Project: New Joplin Library
Site Civil/Landscape Construction Documents
Volume 2 of 2

Client: City of Joplin

ADDENDUM NO. 2

UPDATED DRAWINGS – ADDENDUM #2 LANDSCAPE

SITE PLANTING PLAN

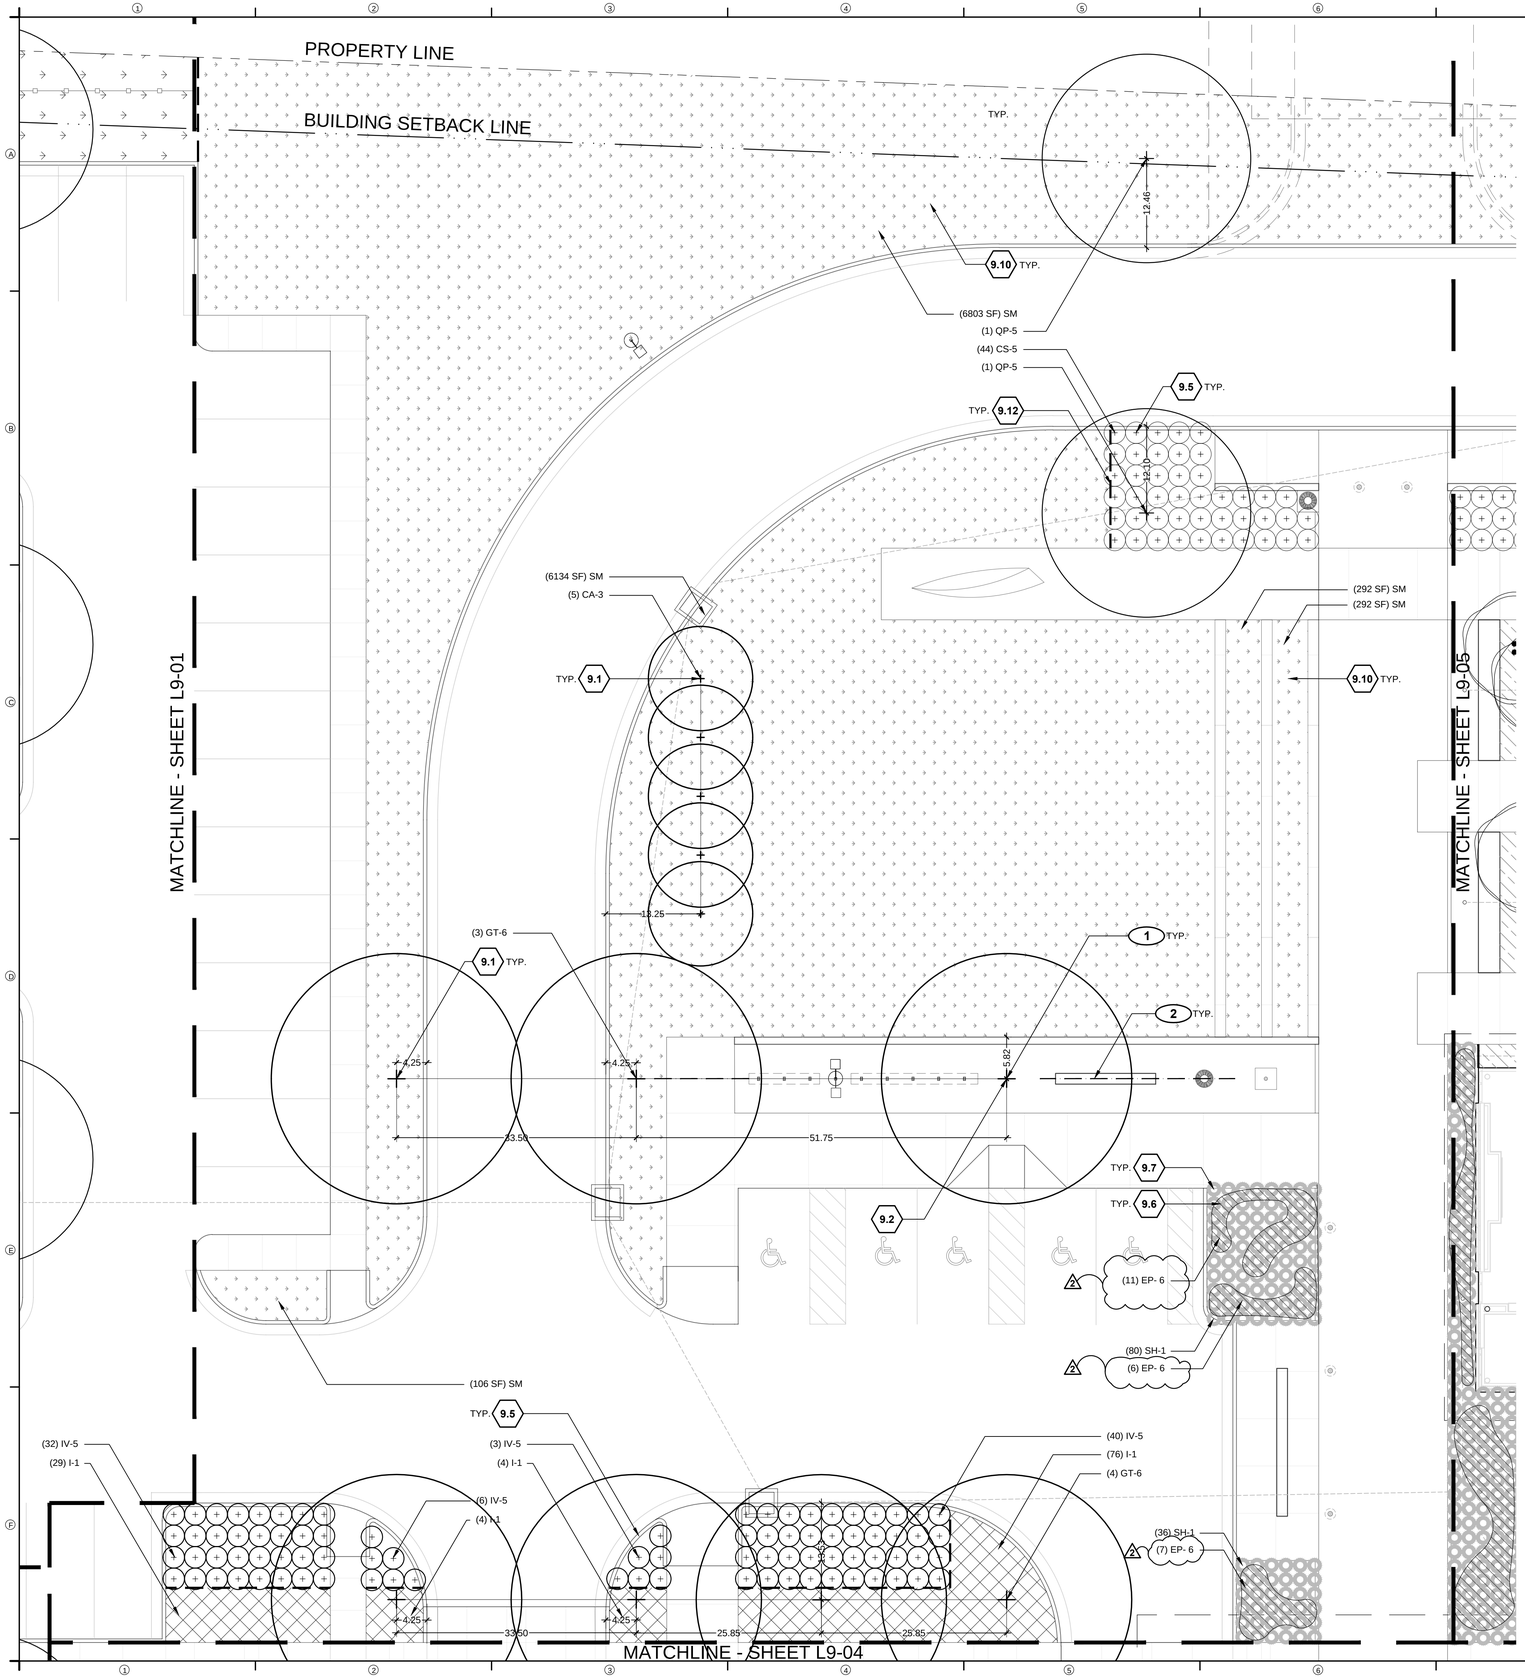
2. Sheet L9-02
a. plan notes a PA-1, legend notes a PA-1 plant type under both Ornamental grasses and Perennials. Which PA-1 is to be used on this sheet?

b. plan shows a plant type PA-3 Which plant is that in the legend?

Sheet L9-02: The Legend has been updated for all sheets to reflect the perennial PA-1 to now be PAF-1 and plan reference to PA-3 has been changed to PA-1 Ornamental Grass.

This is the Ornamental Grass on this sheet. The Legend has been updated for all sheets to reflect the perennial PA-1 to now be PAF-1

SITE PLANTING PLAN

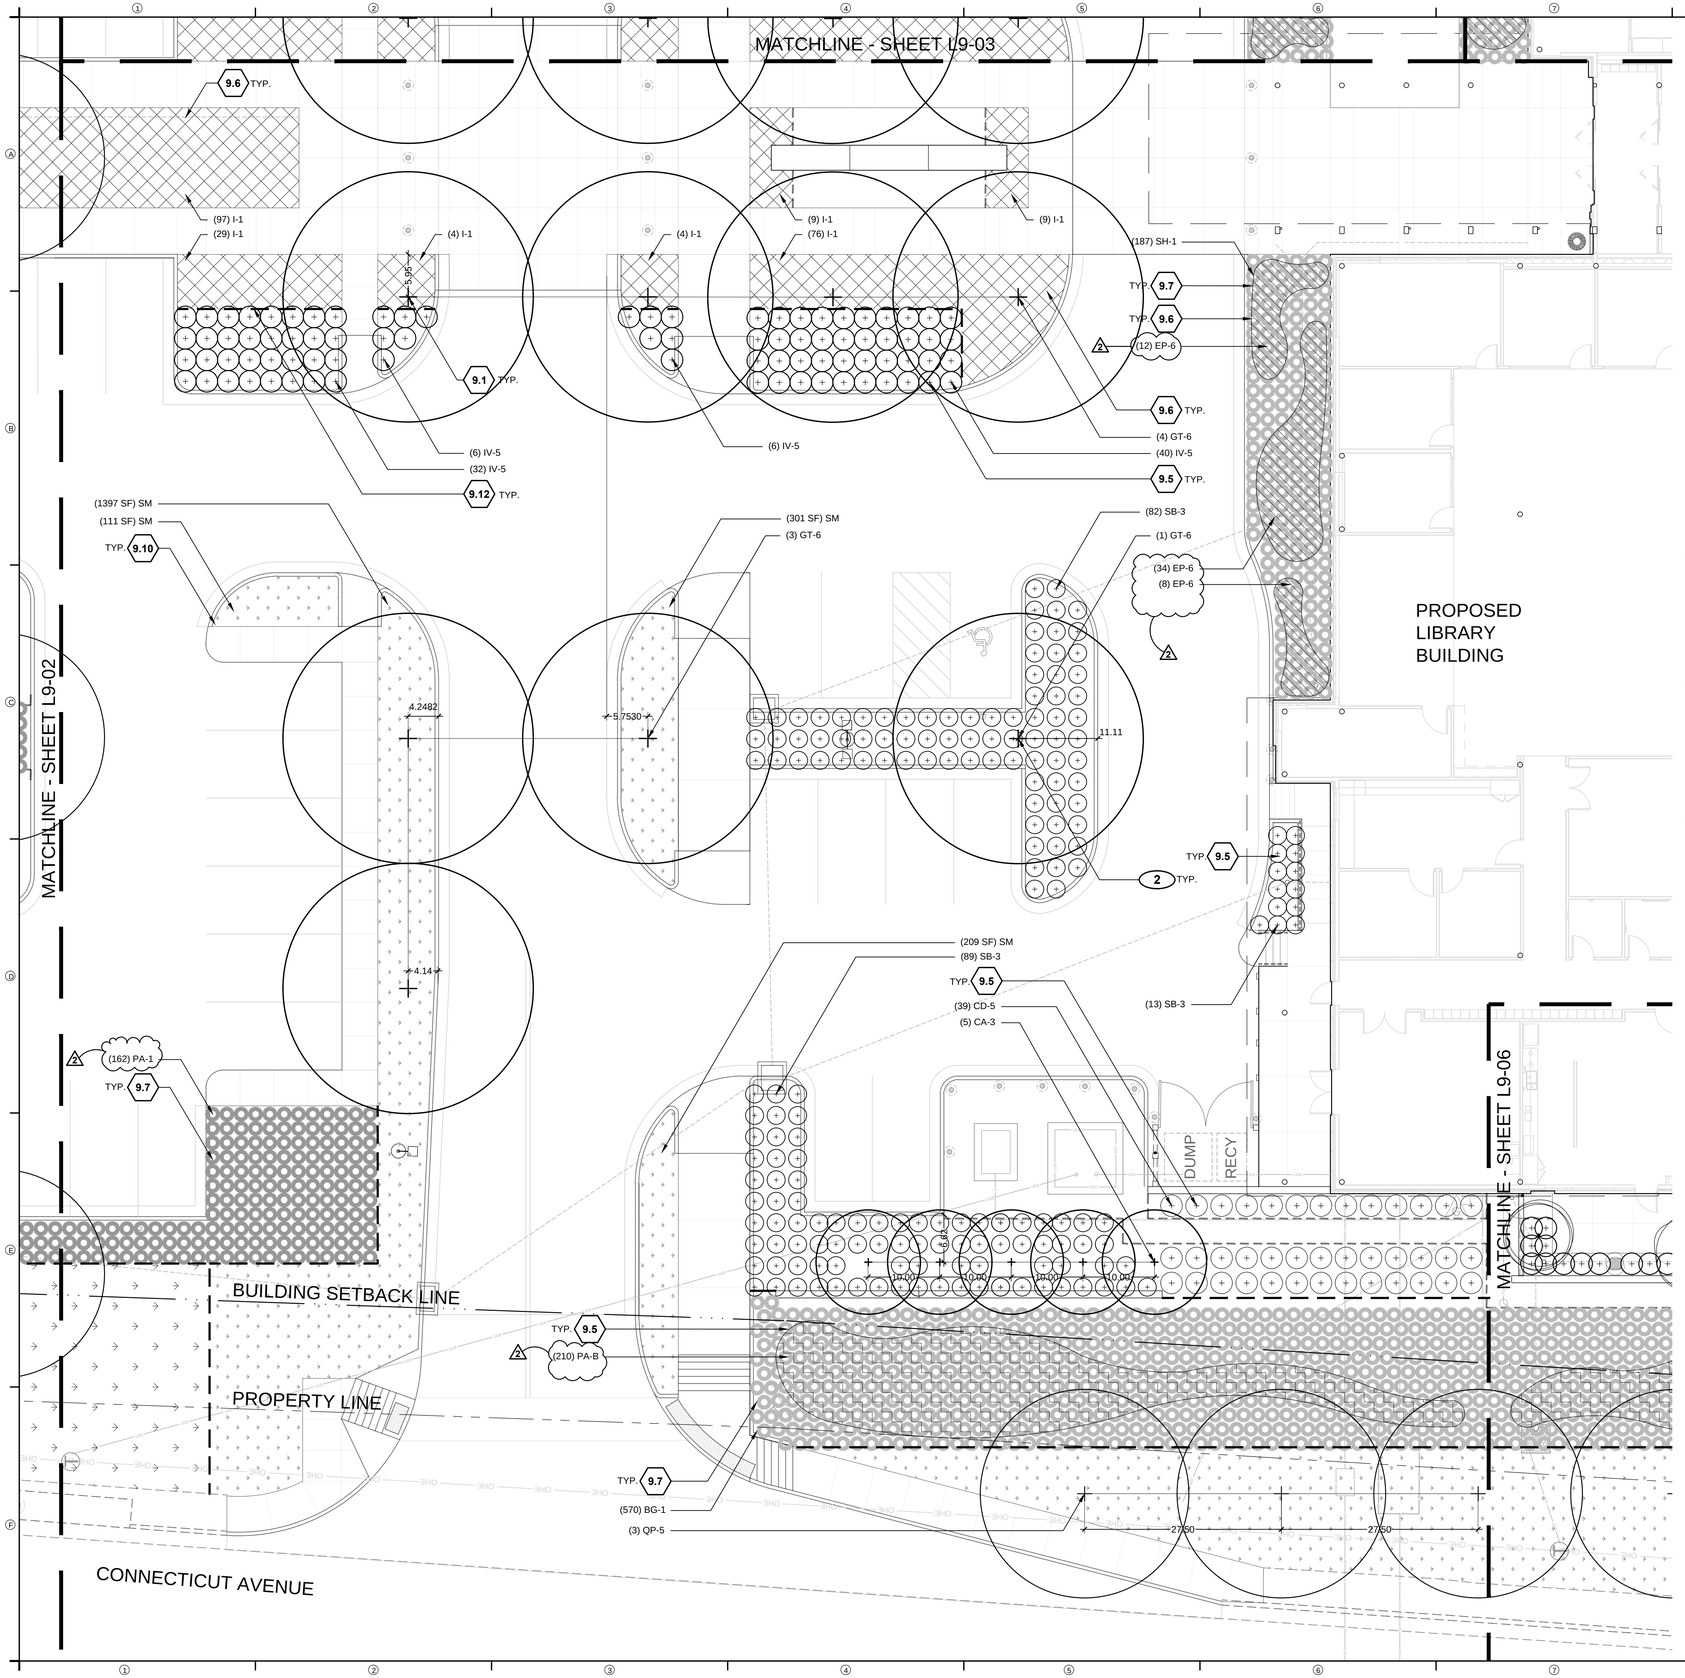
a. plan notes a tree QP-5, legend notes a QP-3 is that the correct type?

b. plan notes a shrub IV-5, legend notes a IV-3 is that the correct type?

c. plan notes a perennial EP-1, legend notes as EP-6 is that the correct type?

Sheet L9-03: The Legend has been updated for all sheets to reflect the change from tree type QP-3 to QP-5, shrub IV-3 to IV-5, as well as perennial EP-1 to EP-6. Plan matches these changes accordingly.

Yes this is correct. Legend has been updated on all sheets to reflect corrections.

Yes this is correct. Legend has been updated on all sheets to reflect corrections.

Yes this is correct. Plan has been updated on all sheets to reflect corrections.

SITE PLANTING PLAN

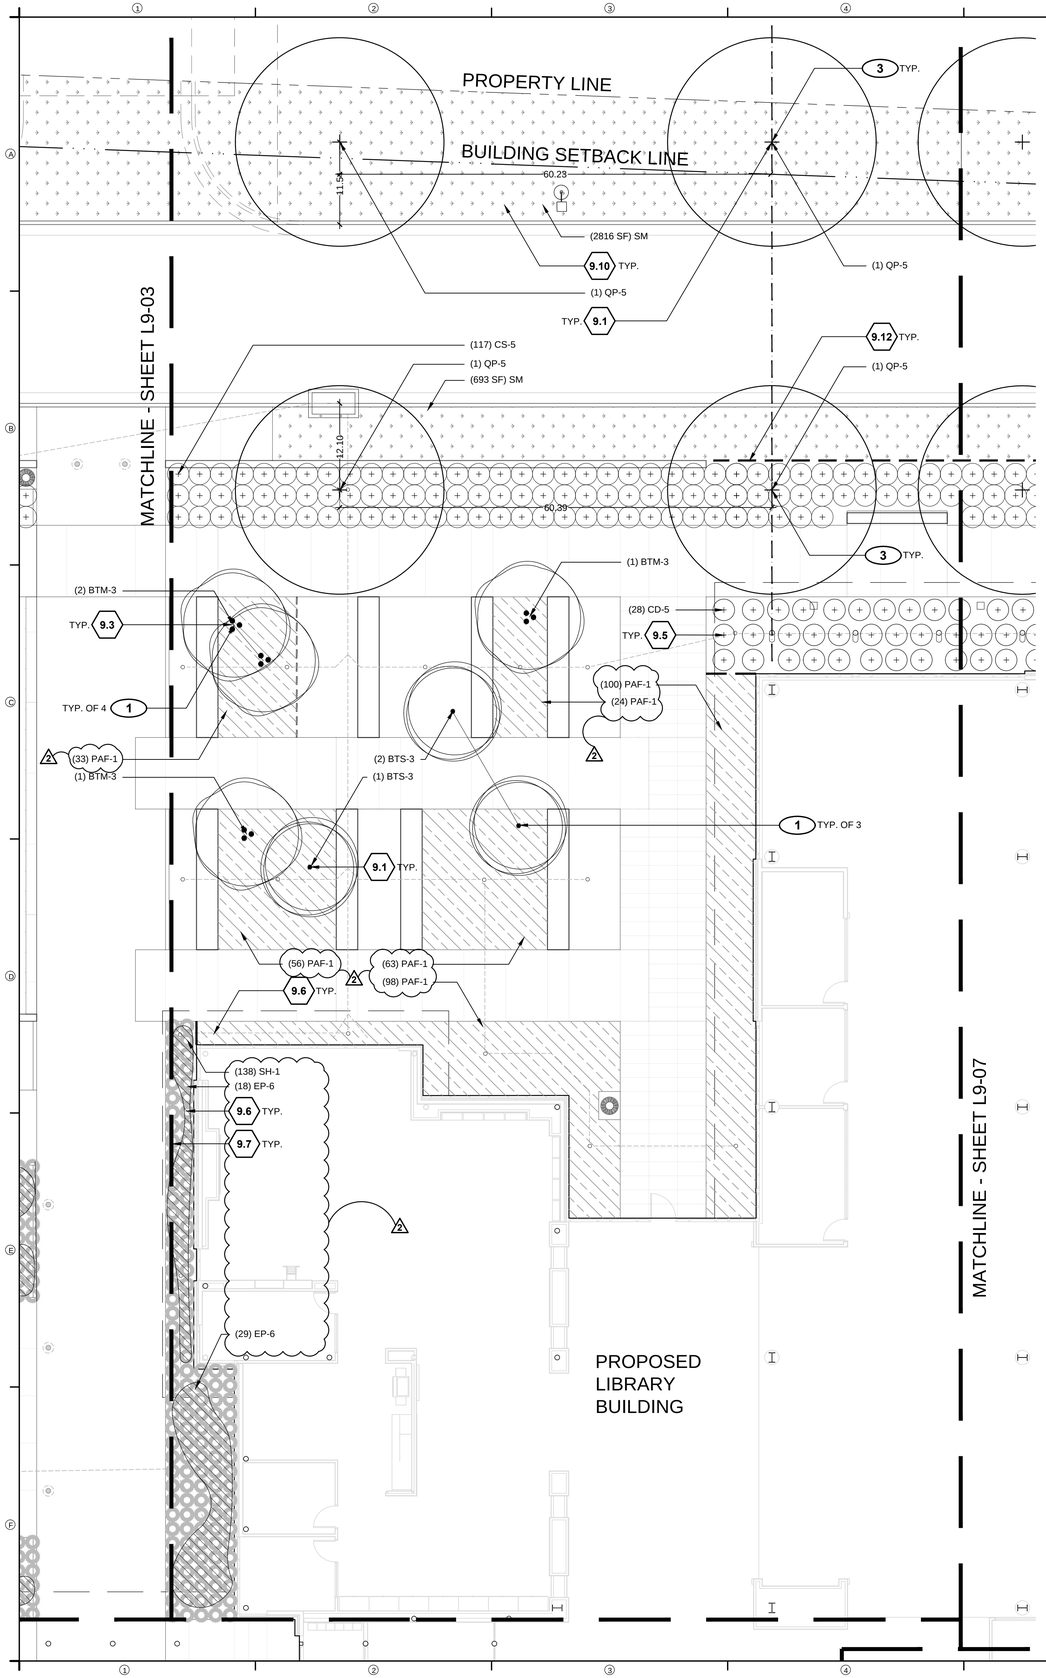
a. plan notes a tree QP-5 legend notes a QP-3 is that the correct type?

b. plan notes a shrub IV-5, legend notes a IV-3 is that the correct type?

c. plan notes a shrub CD-5, legend notes a CD-3 and a CS-5 which is correct?

d. plan notes a plant type PA-3 Which plant is that in the legend? There are 2 different locations looks like 2 different plants.

e. plan notes a perennial EP-1, legend notes an EP-6 is that the correct type?

Sheet L9-04: The Legend has been updated for all sheets to reflect the change from tree type QP-3 to QP-5 and shrub IV-3 to IV-5. Plan has been updated to reflect these changes as well as changing shrub CD-3 to CD-5. Plan has been updated to have PA-1 Ornamental Grass in the lower left planting bed and PA-B (Bulb) in the middle/right planting bed. Plan has been updated from EP-1 to EP-6.

Yes this is correct. Legend has been updated on all sheets to reflect corrections.

Yes this is correct. Legend has been updated on all sheets to reflect corrections.

Legend was incorrect. Should be CD-5 as on plan. Legend has been updated to reflect corrections.

Yes this is correct. Plan has been updated on all sheets to reflect corrections.

SITE PLANTING PLAN

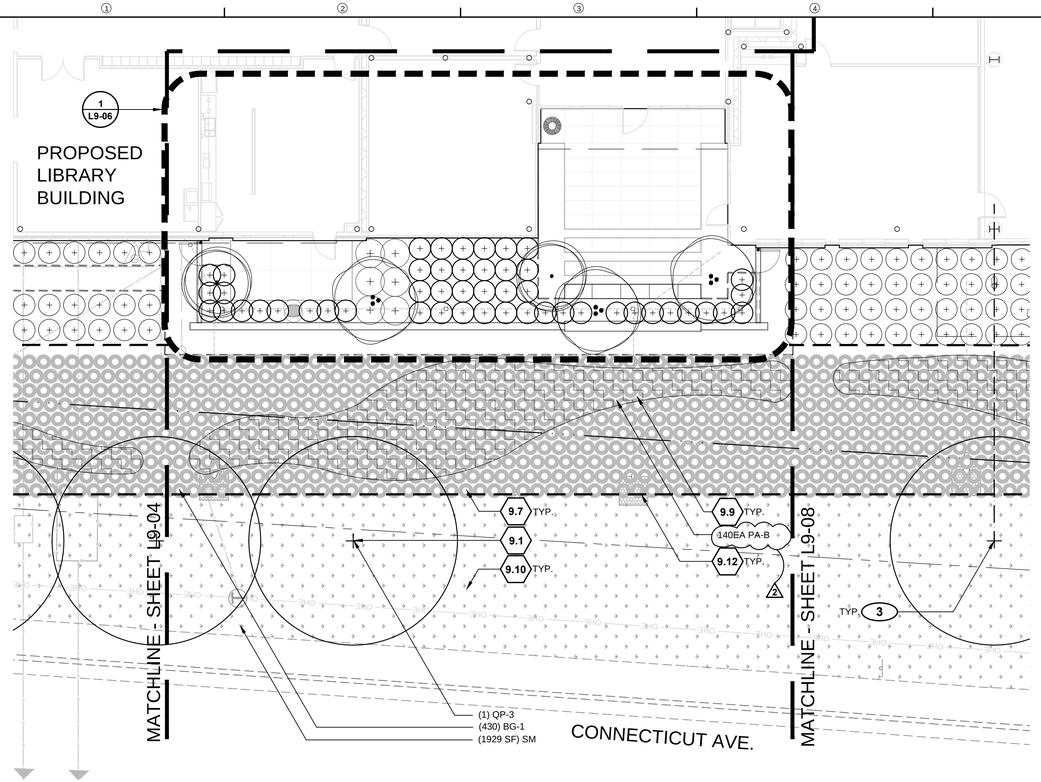
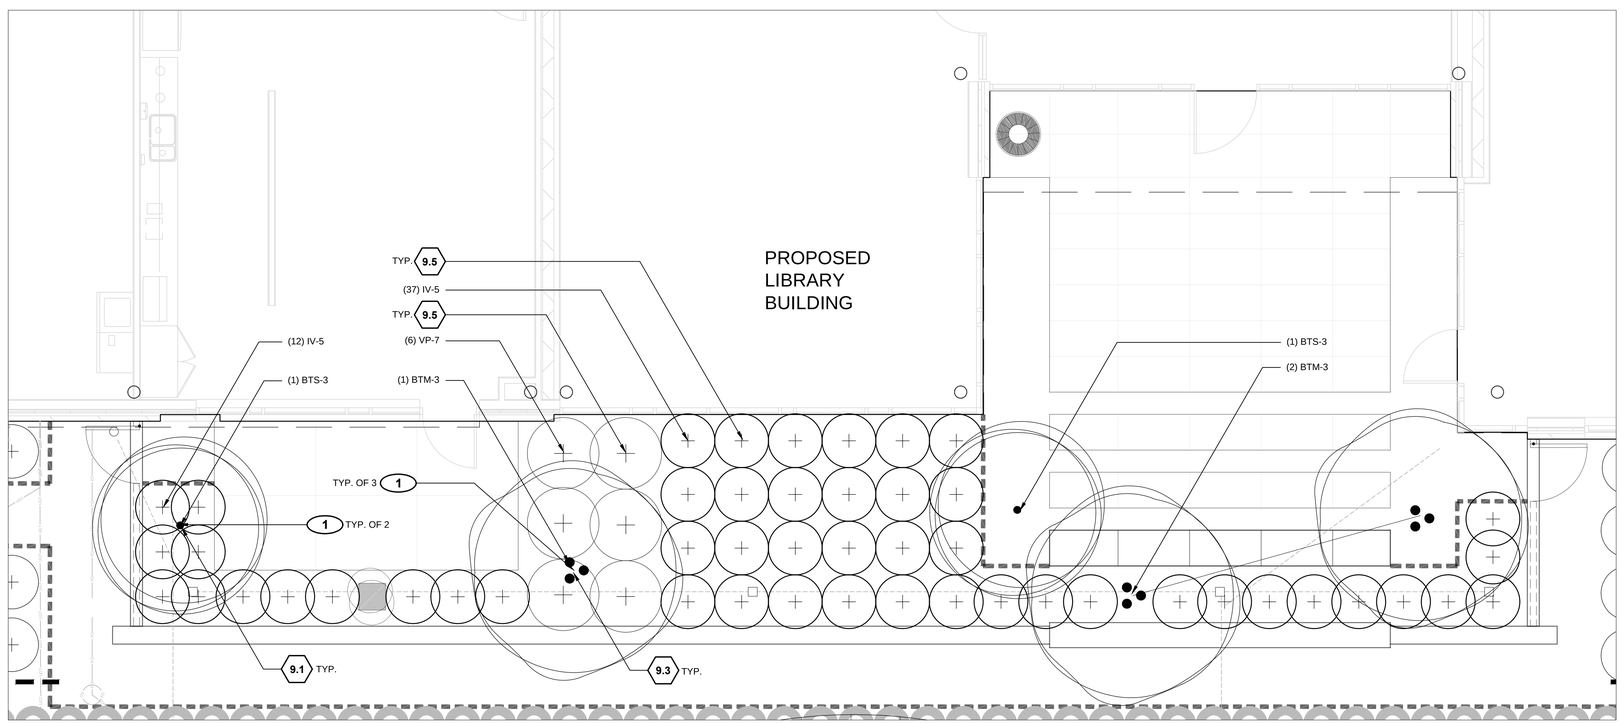
a. plan notes a tree QP-5, legend notes a QP-3 is that the correct type?

b. plan notes a shrub CD-5 legend notes a CD-3 and a CS-5 which is correct?

c. plan notes a plant PA-1 legend notes a PA-1 under both Ornamental grass and Perennials. Which PA-1 is to be used on this sheet?

d. plan notes a plant EP-1 legend notes an EP-6 is that the correct type?

Sheet L9-05: The Legend has been updated for all sheets to reflect the change from tree type QP-3 to QP-5 and shrub CD-3 to CD-5. Plan has been updated from PA-1 to PAF-1 (perennial fern) as well as updating EP-1 to EP-6.

Yes this is correct. Legend has been updated on all sheets to reflect corrections.

Legend was incorrect. Should be CD-5 as on plan. Legend has been updated to reflect corrections.

PA-1 on this sheet referenced Perennial Fern. This has been updated on drawings and all legends to now be represented as PAF-1 (ornamental grass remains PA-1)

Yes this is correct. Plan has been updated on all sheets to reflect corrections.
